## **RESPONSE TO REQUEST FOR FURTHER INFORMATION – DOC RAL Whakapapa Gondola Application**

**Subject:** Response to request for further information from Department of Conservation, dated 1 March 2018

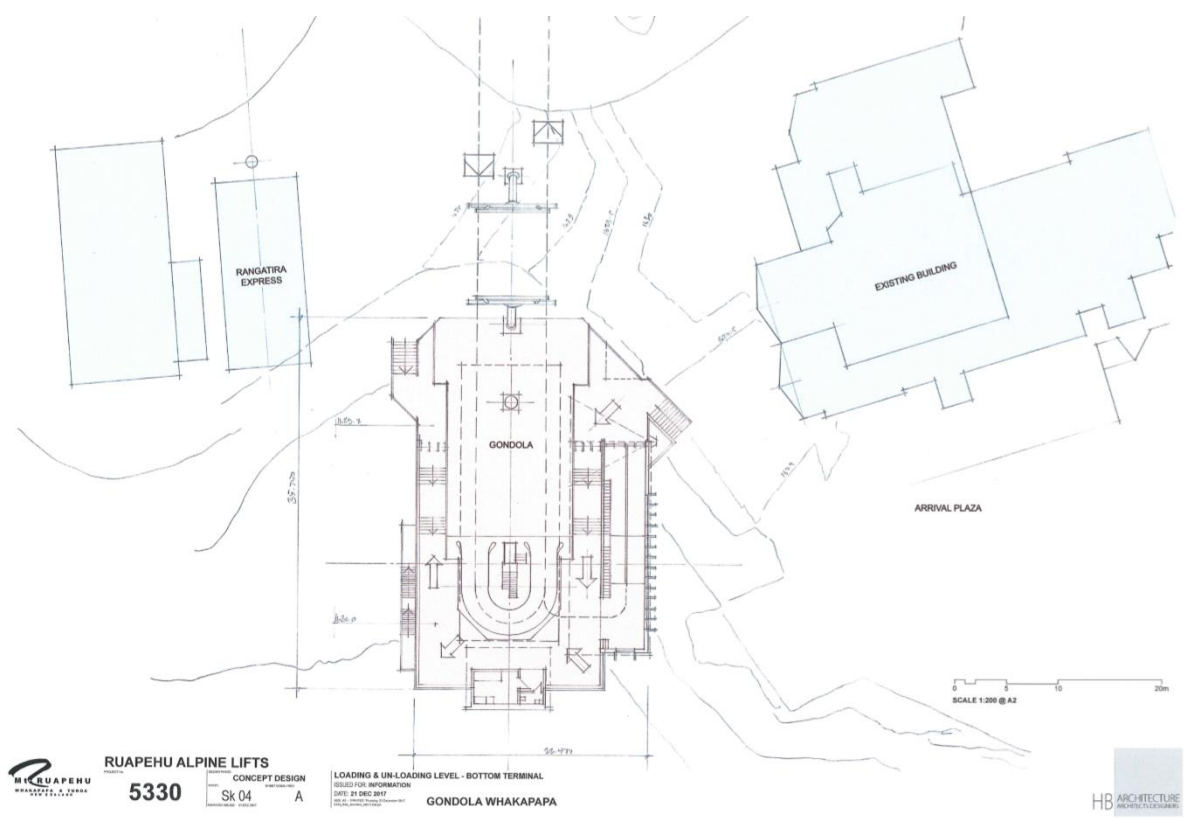
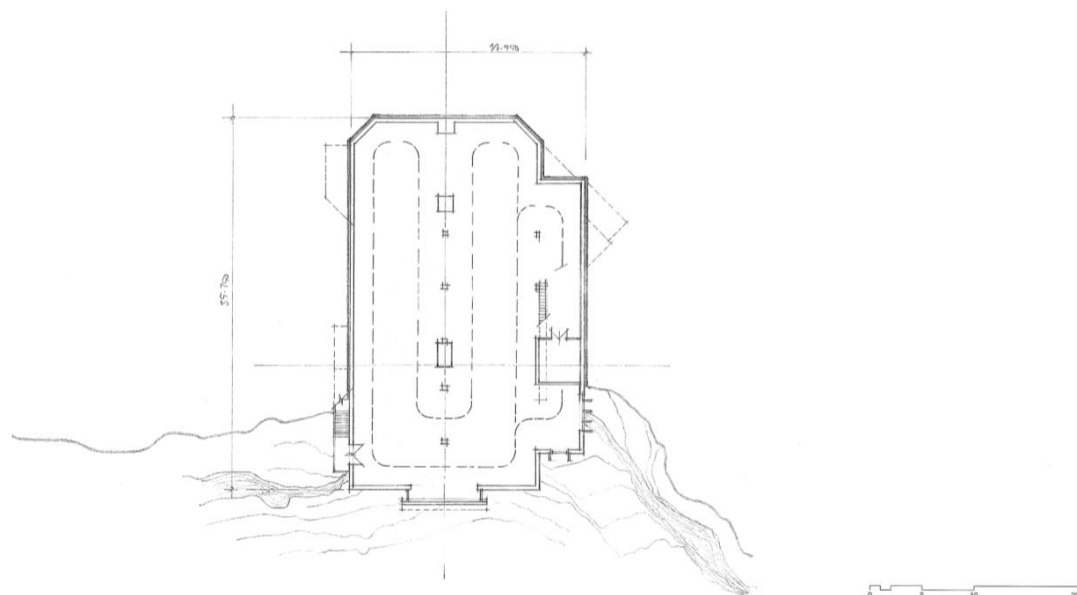
***2. What will be the visual impact of services placed on site such as Comms cables, power cables etc. Will they be trenched or above ground?***

The comms cables will be trenched where possible (from the lower terminal to beyond Hut Flat). The cable will be overground where the rock is a solid welded lava flow. Where possible small rocks will be used to disguise the cables. There will be no power cables required.
